Name: Midas Muffler - 101 North Avenue - Site Plan Review

Community Development Review Comments

Project: Site Plan Review for Midas Muffler and Lube Shop
Location: 101 North Avenue
File: #10-93
Petitioner: Terry McClain

REVISED PLAN
2-17-93

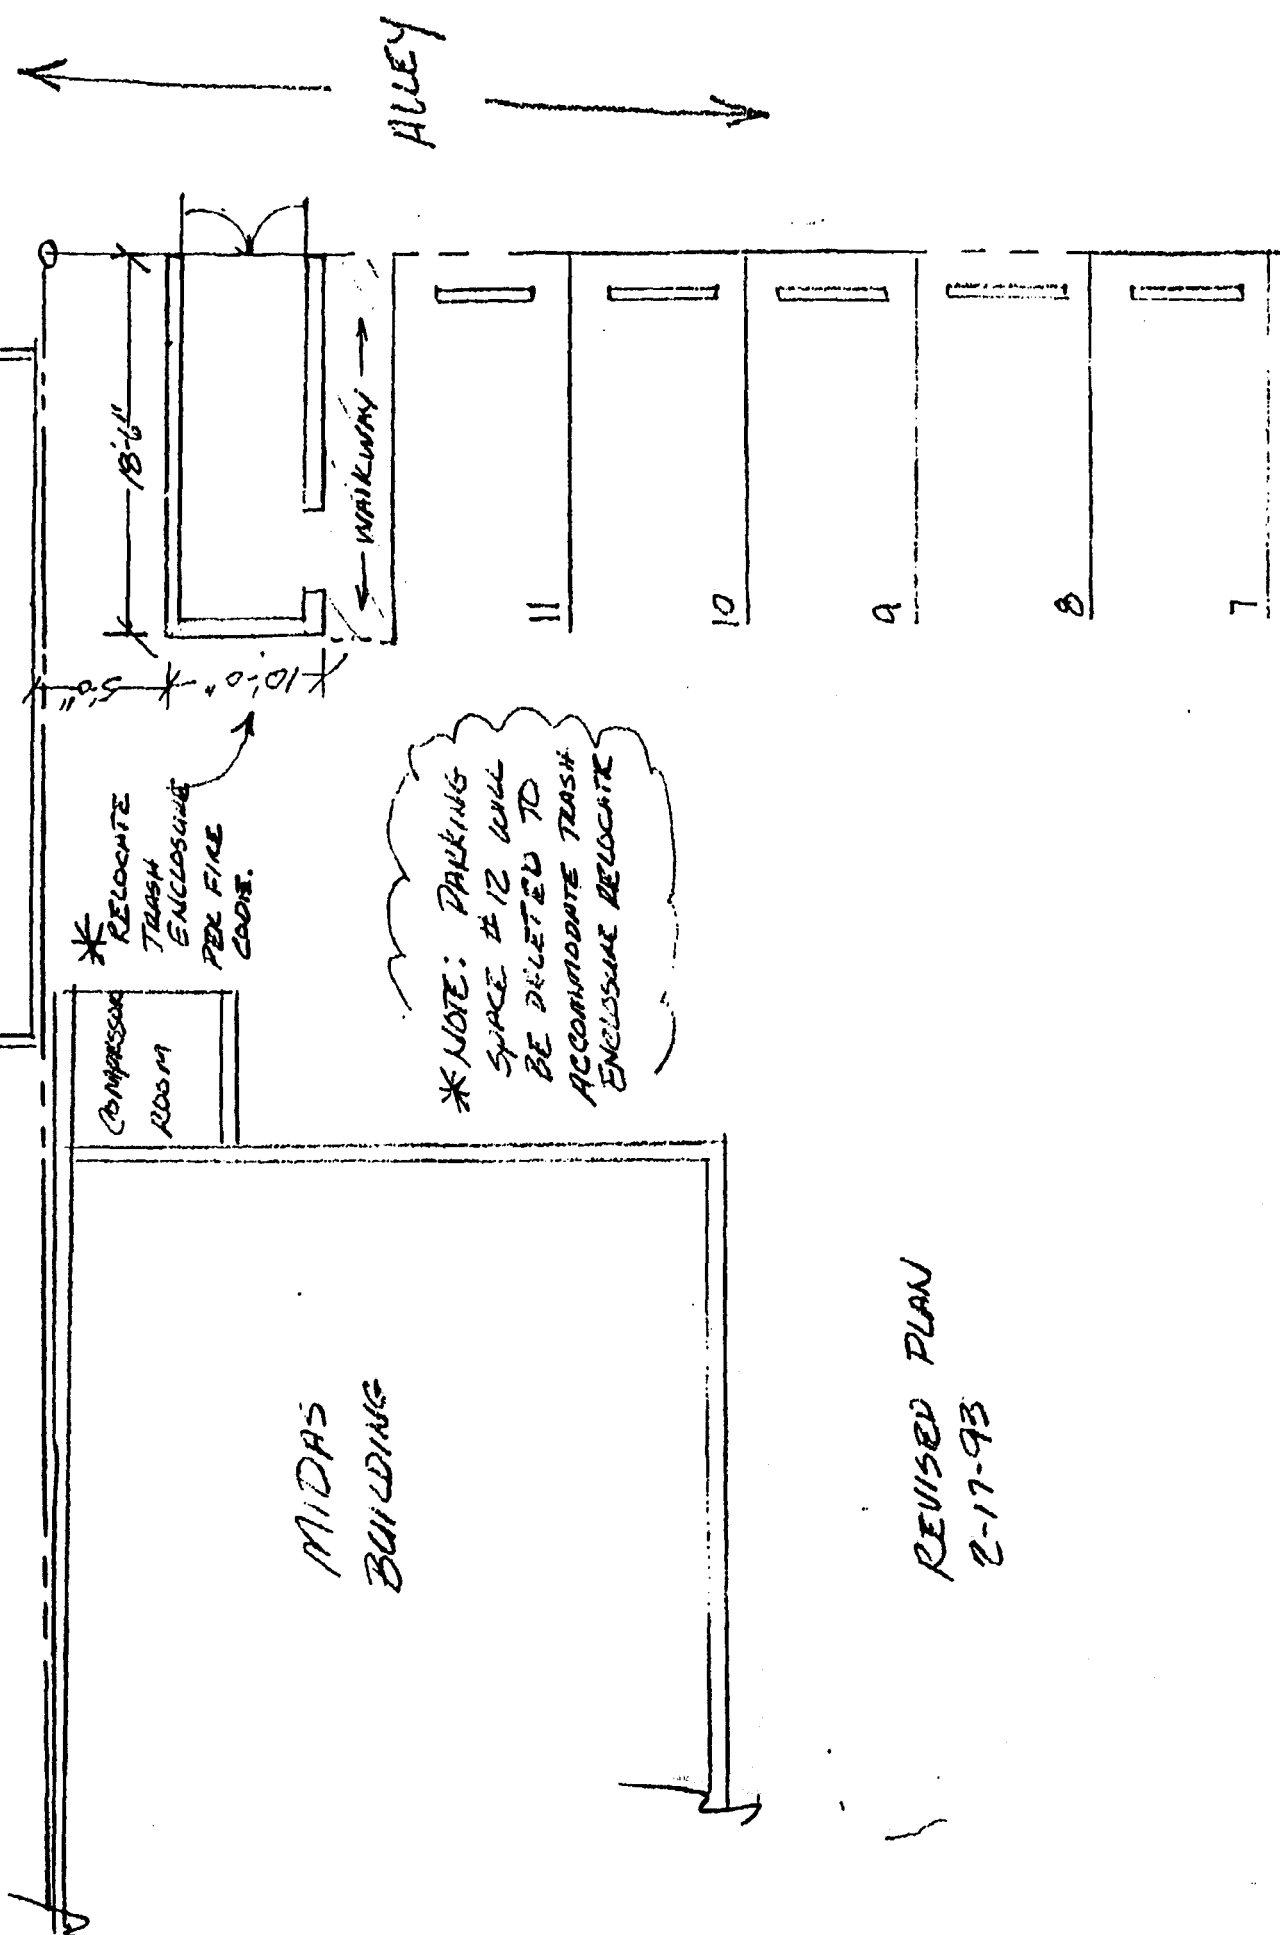
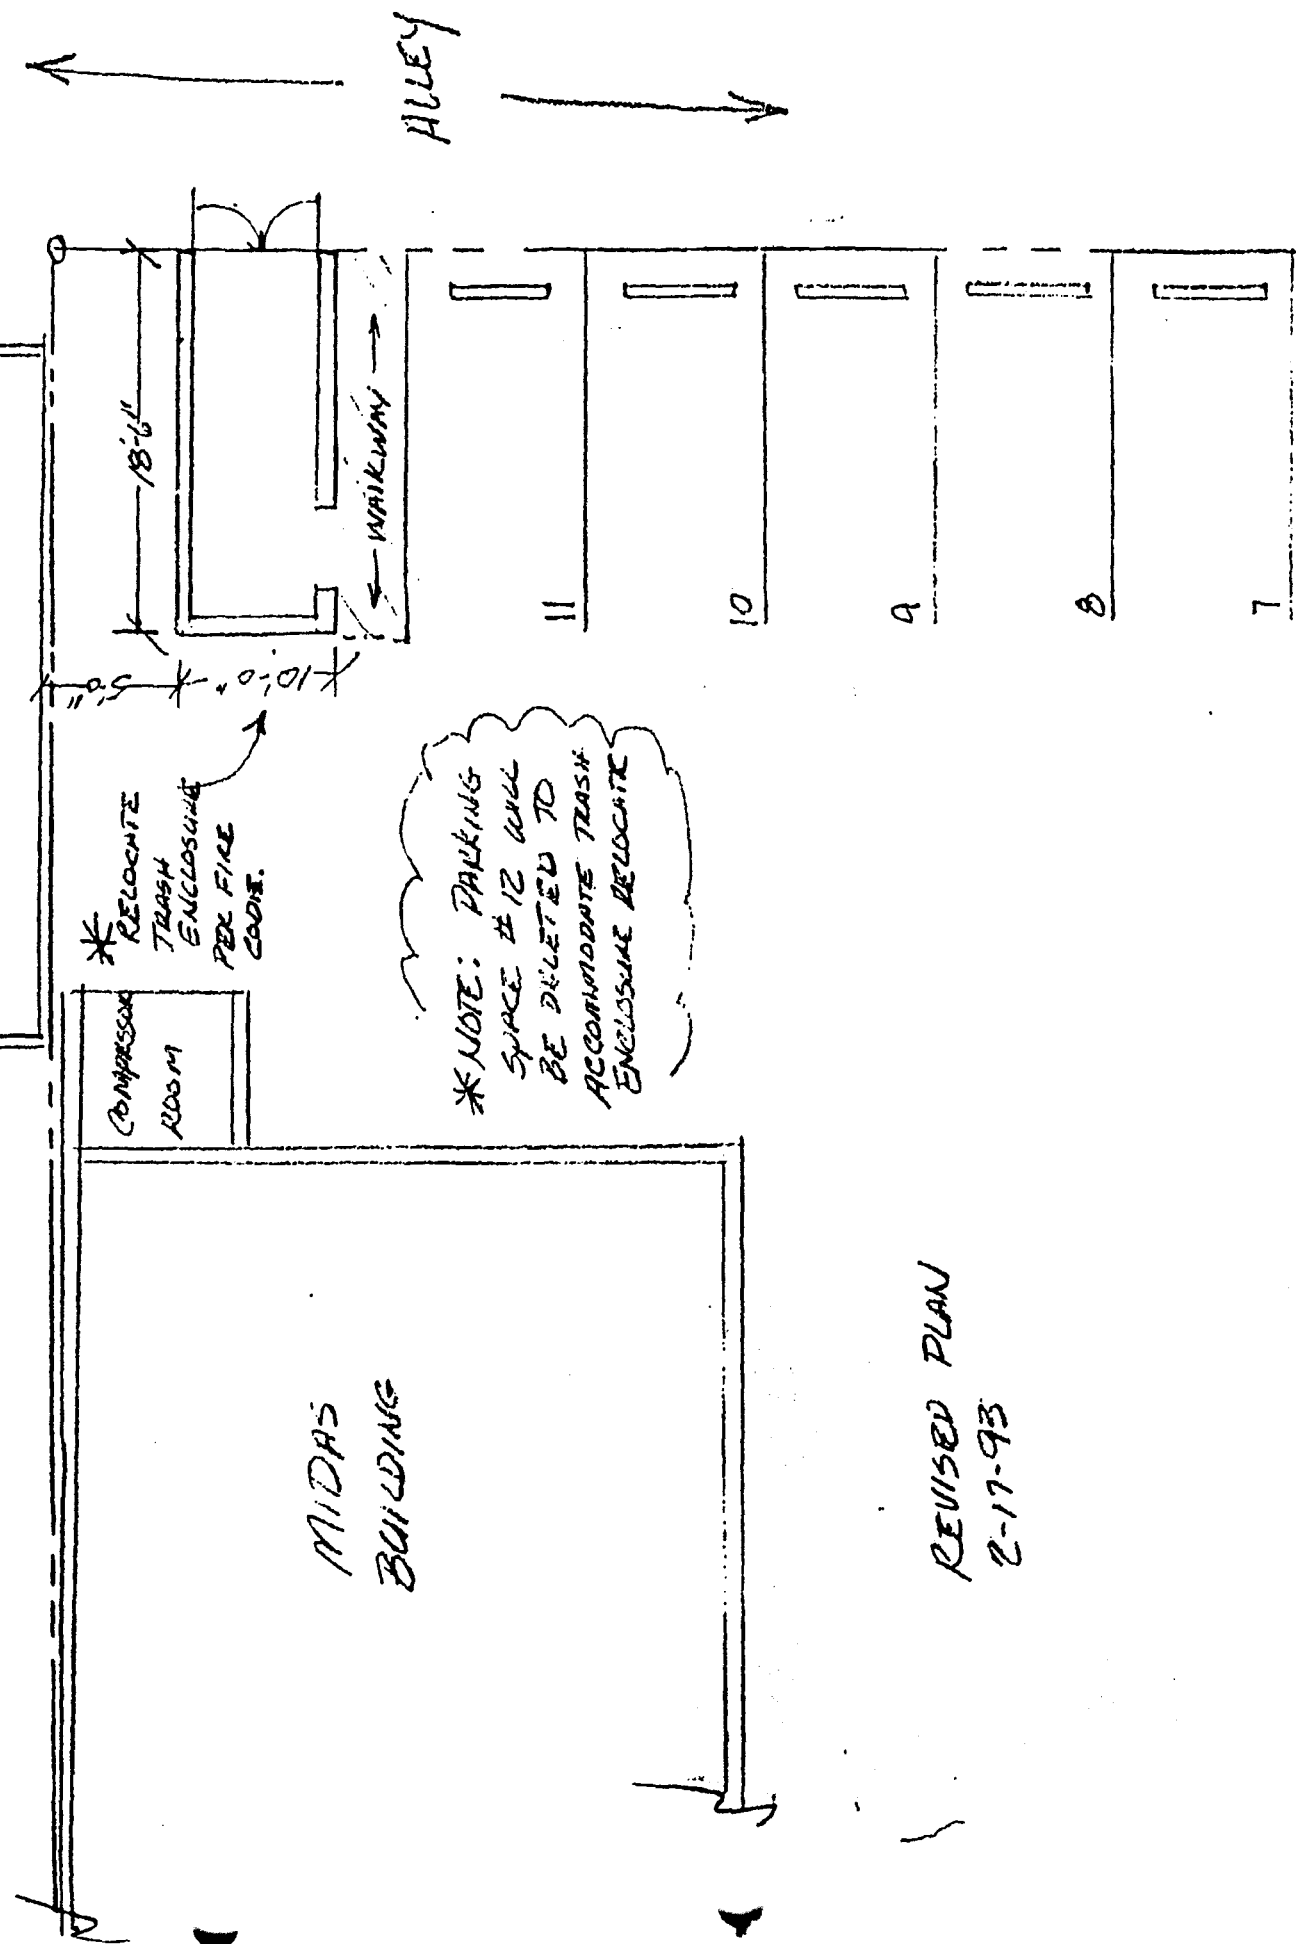
1. Dumpster location needs to be reconsidered. Perhaps closer to the alley for better pick-up would be more appropriate. Please contact Darren Starr at 244-1493 regarding the dumpster location.

2. Parking space #12 is unusable due to the space requirement needed to back a vehicle up. If the dumpster location is moved closer to the alley, this may alleviate the backing problem.

1. See attached revised dumpster location.
2. We will give up parking space #12 for new dumpster location.
3. Available parking will become 15 total. This is due to new dumpster location required by the Fire Department.
4. Recording fees will follow this letter along with revised plans as soon as they are complete.

* RELOCATE
TRASH
ENCLOSURE
PER FIRE
CODE.

* NOTE: PARKING
SPACE # 12 WILL
BE DELETED TO
ACCOMMODATE TRASH
ENCLOSURE RELOCATE
